Addendum No. 1

Date: 11.10.2022

Project: Missouri Western State University – Cross Country Building – FB23-054

SHEET:
A421

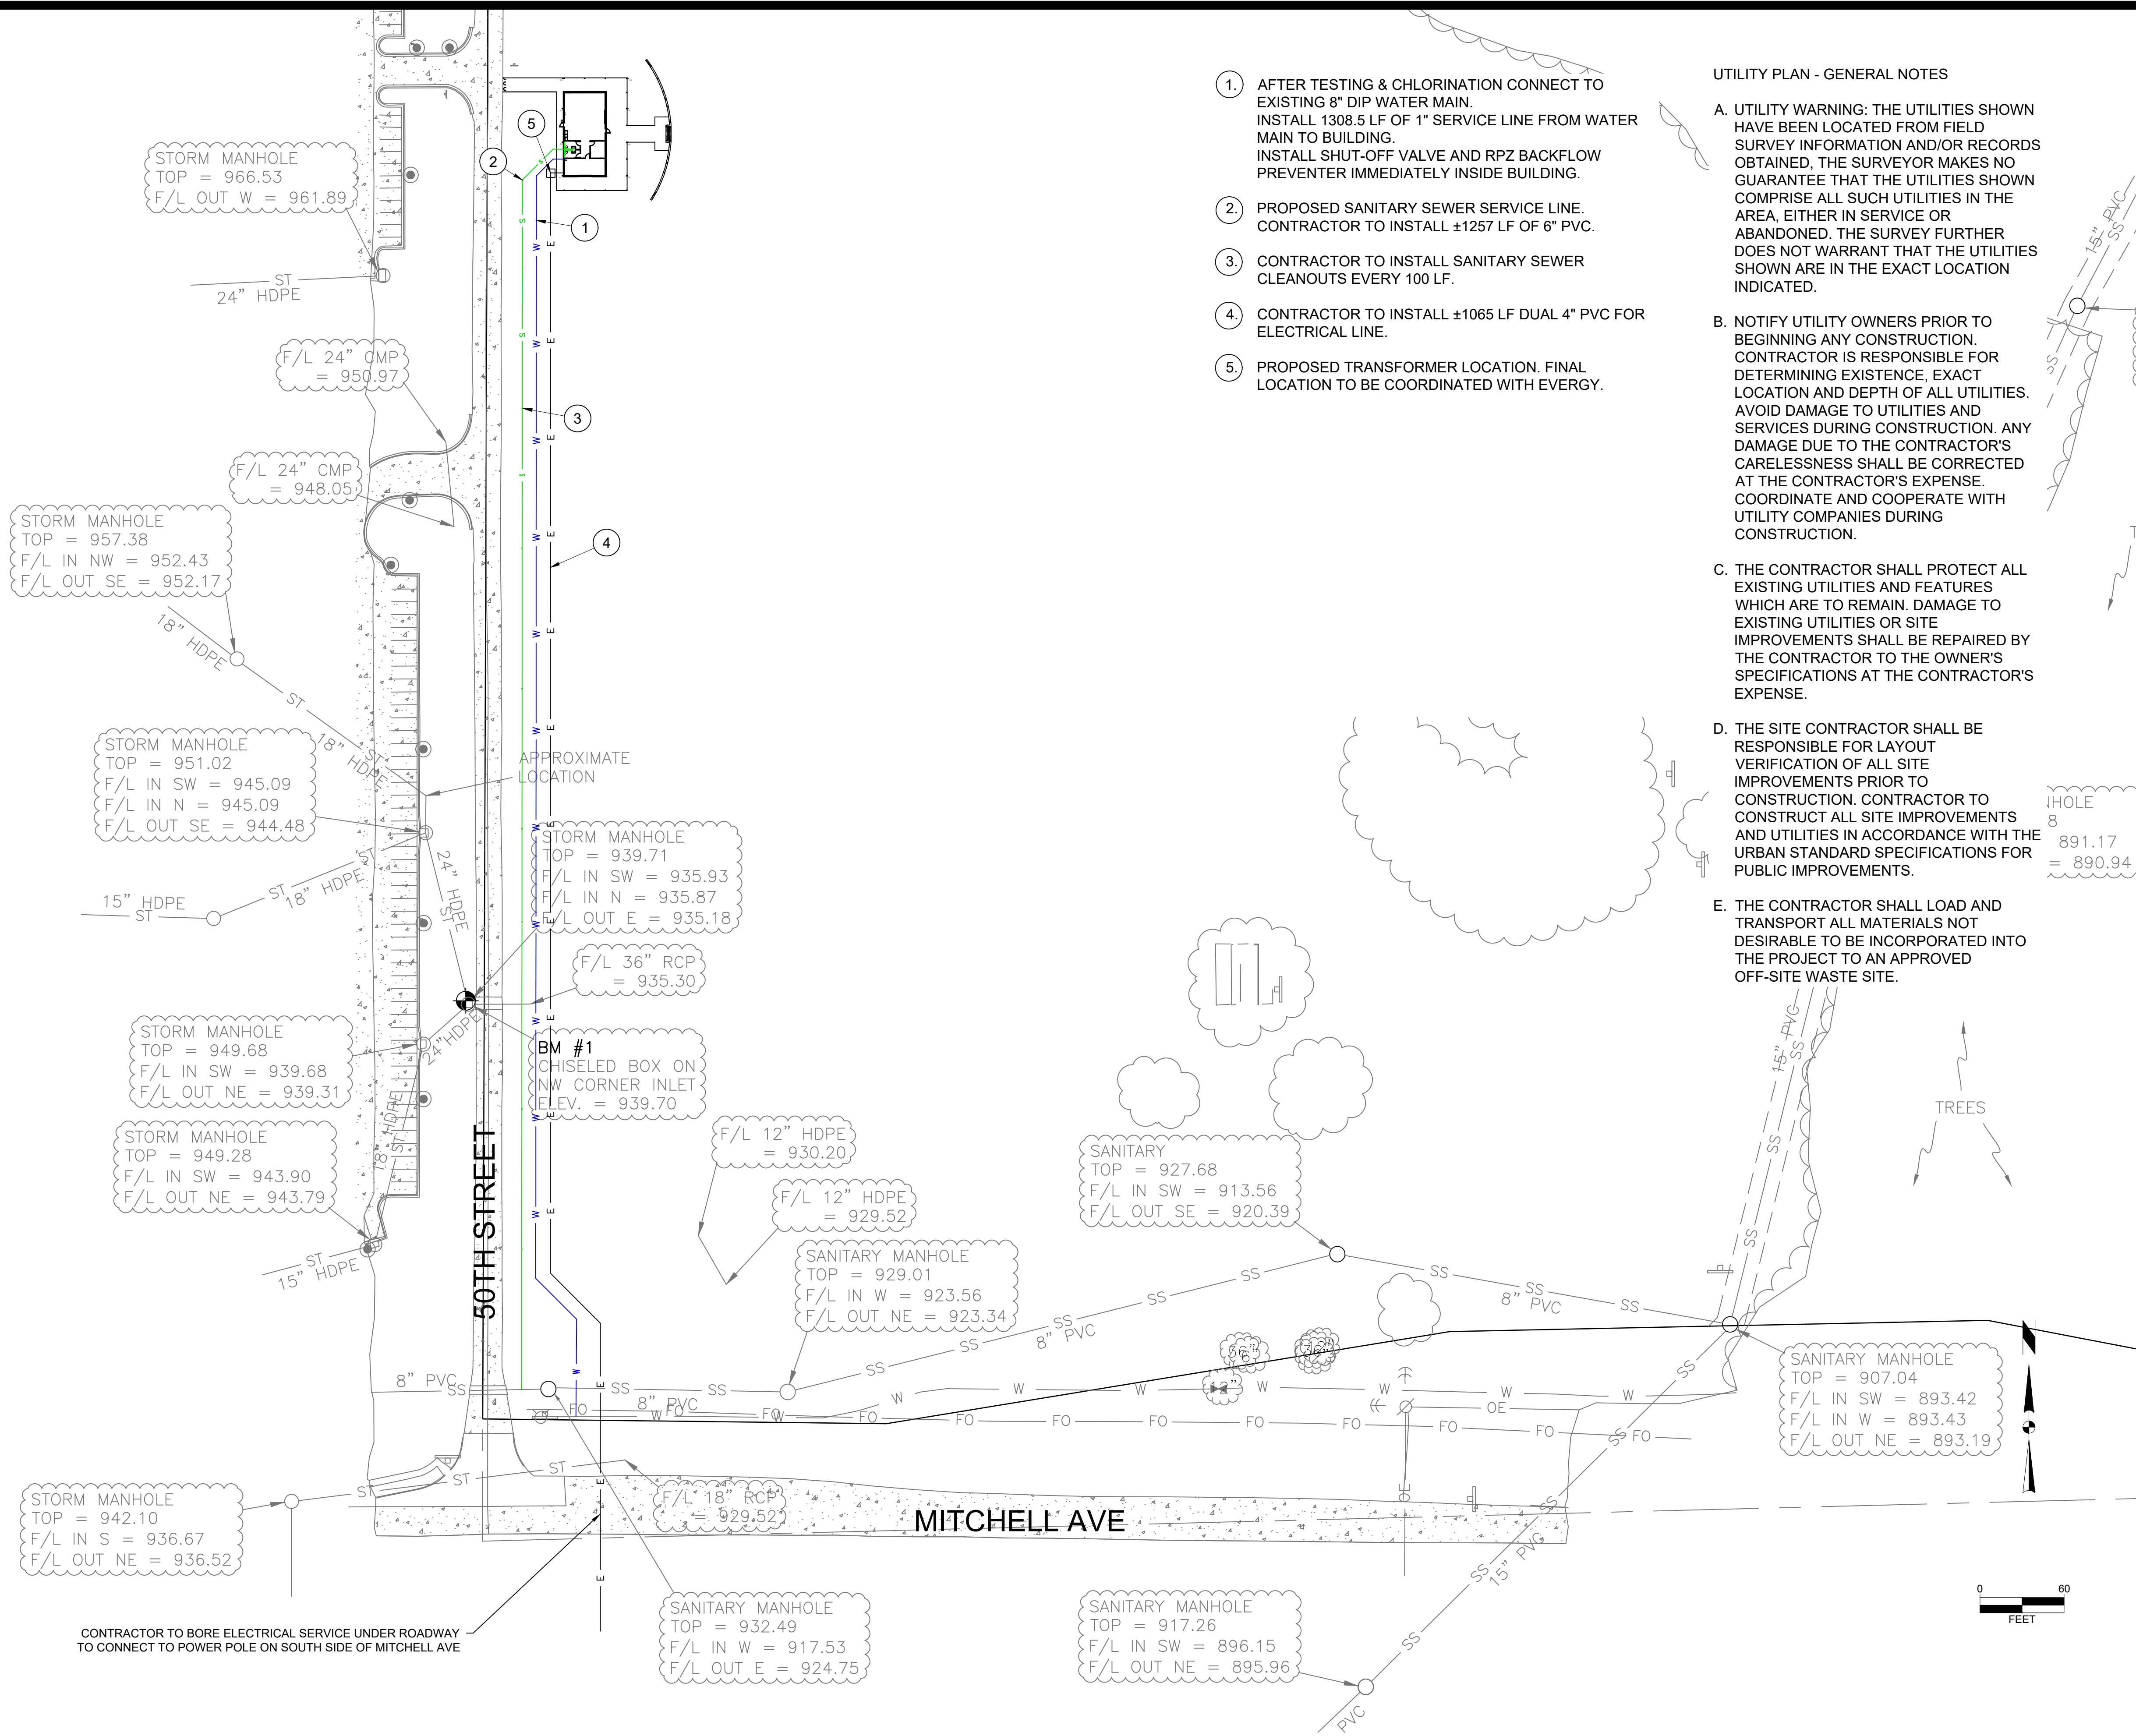
1. Please see the attached pre bid sign in sheet.
2. The exterior sheathing shall be 7/16" osb on walls and 5/8" osb on roof.
3. See attached sketch for sidewalk and step layouts.
4. Contractor is responsible for rough in only for low voltage and data.
5. Sectional doors shall have a 20 gauge exterior and 27 gauge interior, insulated, no windows and a trolley operator
6. Approved substitute manufacturers are:
 - a. PPG paints
 - b. Benjamin Moore paints
 - c. Tnemec fluid applied flooring
 - d. Master Builders – masterSeal AWB 660
 - e. Raynor AP138 overhead door, with Liftmaster Model L18900W.

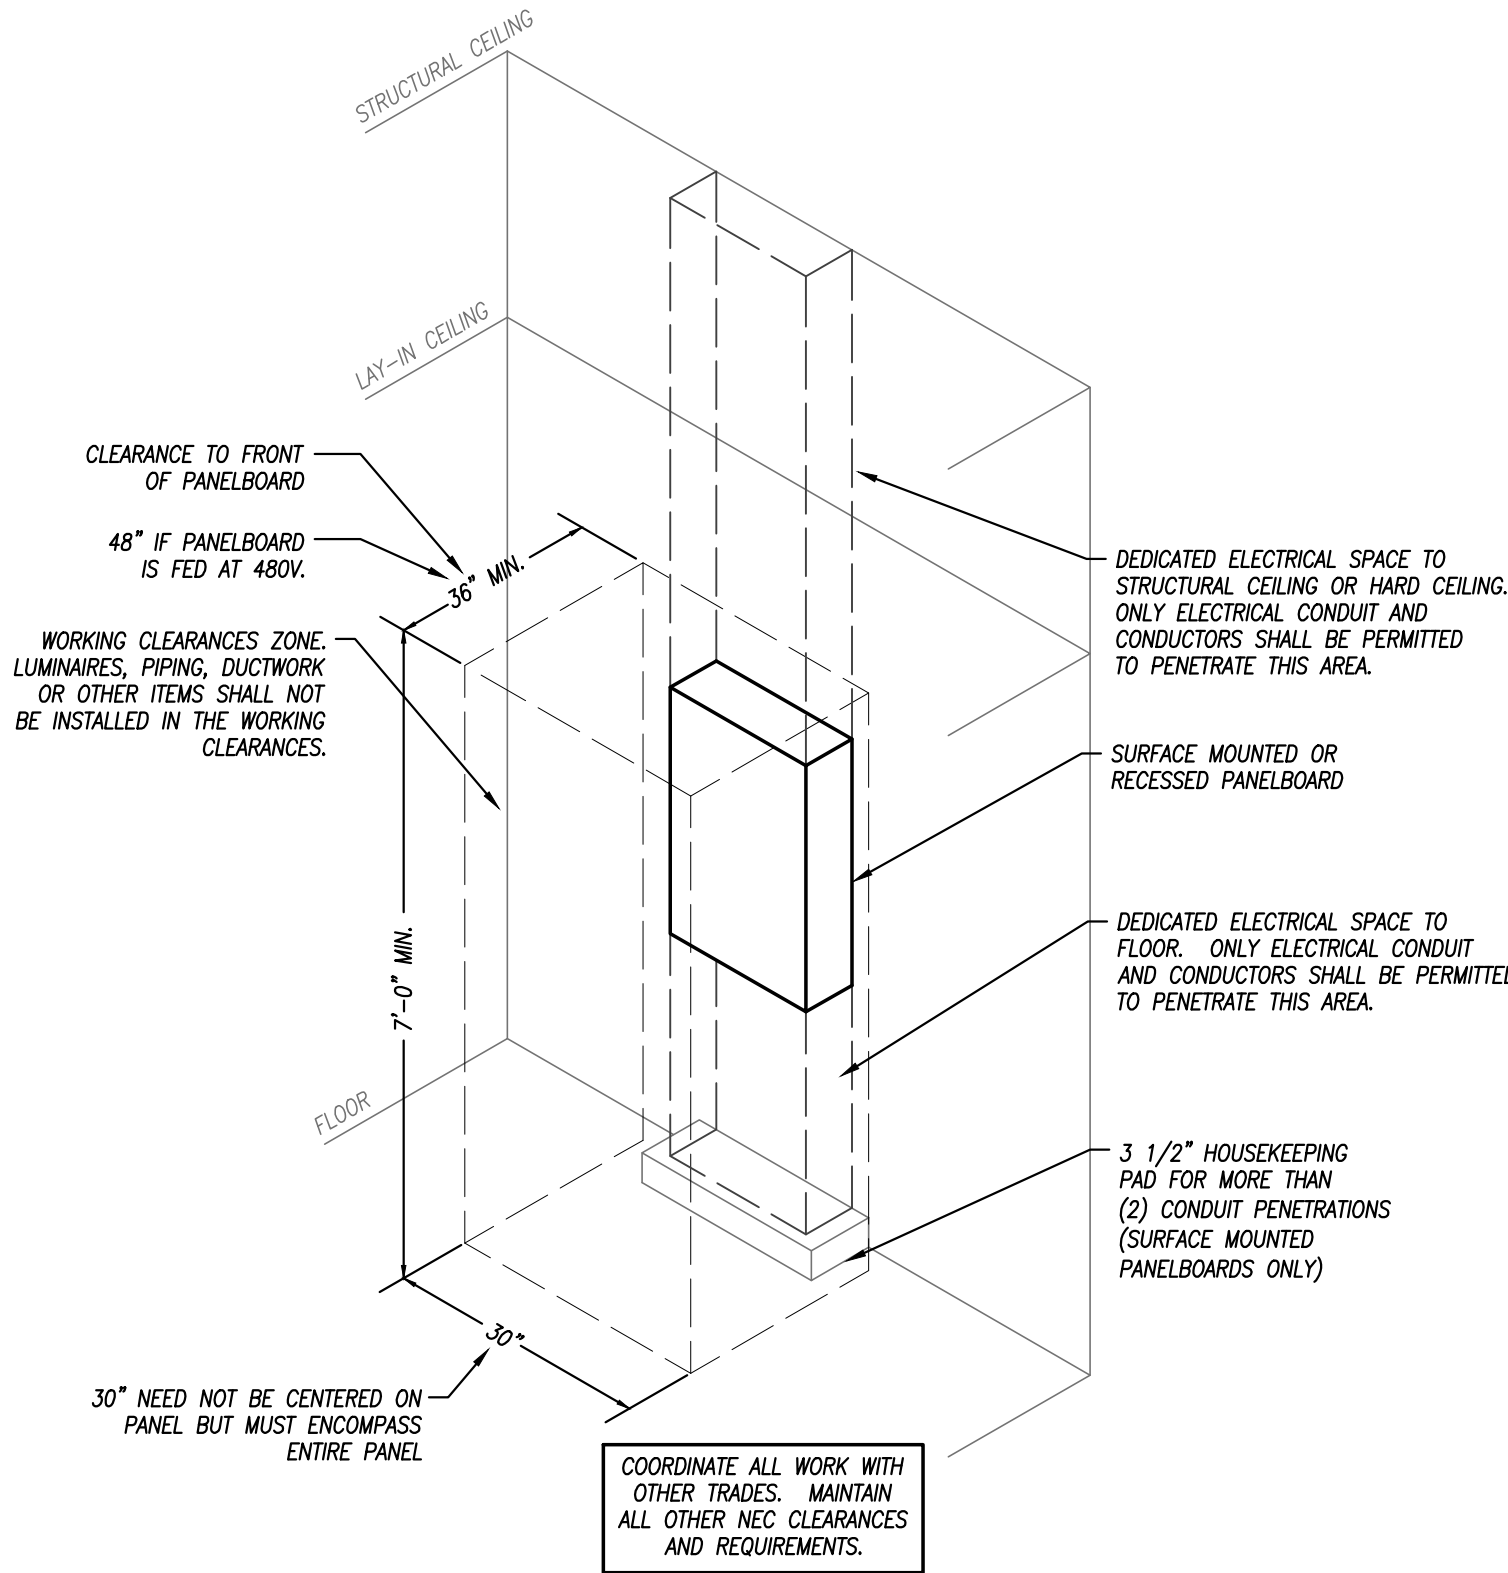
1. See attached for added receptacles.
2. Approximate distance from building to finish line is 900'.

- 1 POWER FOR WATER FOUNTAIN.
- 2 PROVIDE DEDICATED CIRCUIT ON SITE TO FINISH LINE. COORDINATE WITH ARCHITECT FOR FINAL LOCATION. COORDINATE POWER REQUIREMENTS AND WIRE LENGTH FROM ROUGH IN TO ACCOUNT FOR ANY VOLTAGE DROP. PROVIDE ADDITIONAL 1" EMPTY CONDUIT WITH PULL STRINGS FOR CONTROL CABLEING.
